**ADDENDUM NO. 1 - TO
SPECIFICATIONS AND CONTRACT DOCUMENTS
LEWISBURG ELEMENTARY SCHOOL
AND
LEWISBURG PRIMARY SCHOOL
CLASSROOM EXPANSION
DESOTO COUNTY, MISSISSIPPI
FOR
DESOTO COUNTY SCHOOLS**

JANUARY 12, 2017

This addendum forms a part of the Contract Documents and modifies the original specifications and drawings, dated 12-6-16 as noted below. Acknowledge receipt of this Addendum in the space provided on the Bid Form. Failure to do so may subject Bidder to disqualification.

ROOF FRAMING PLAN

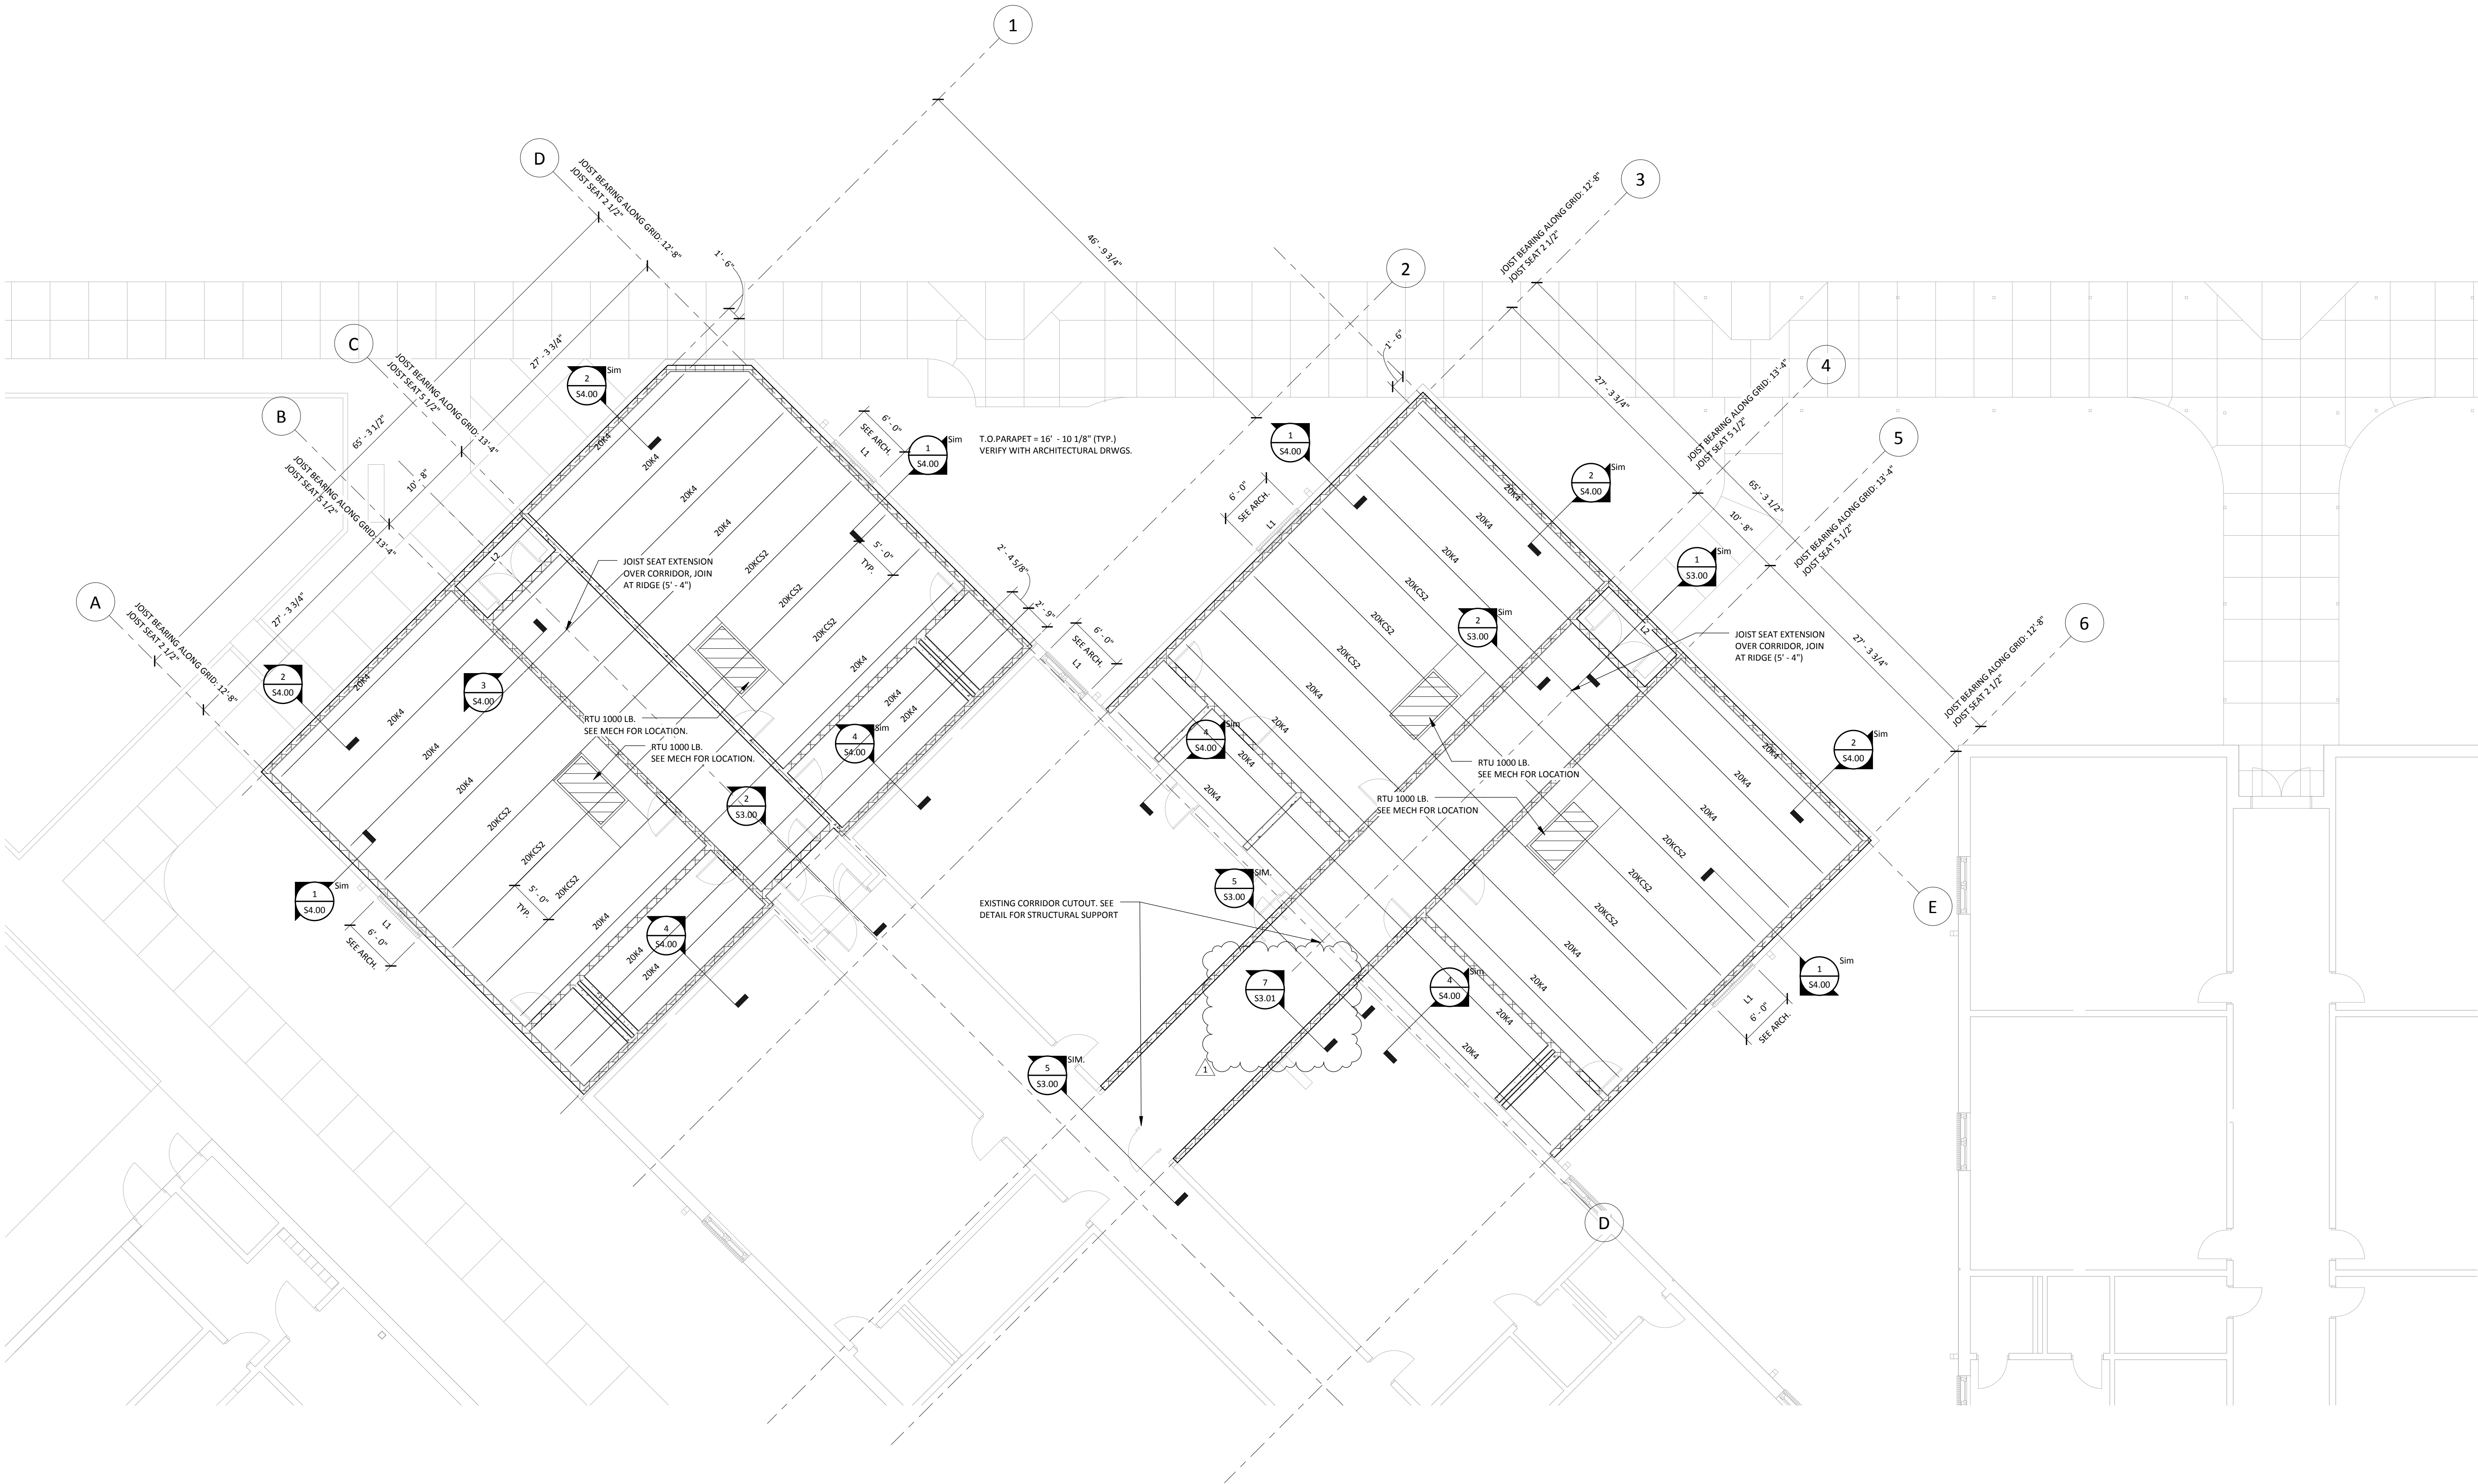
- Item No. 18: DRAWINGS, SHEET S2.01 – ROOF FRAMING PLAN: Remove and destroy this sheet and insert the attached revised Sheet S2.01 – ROOF FRAMING PLAN dated 1-12-17.
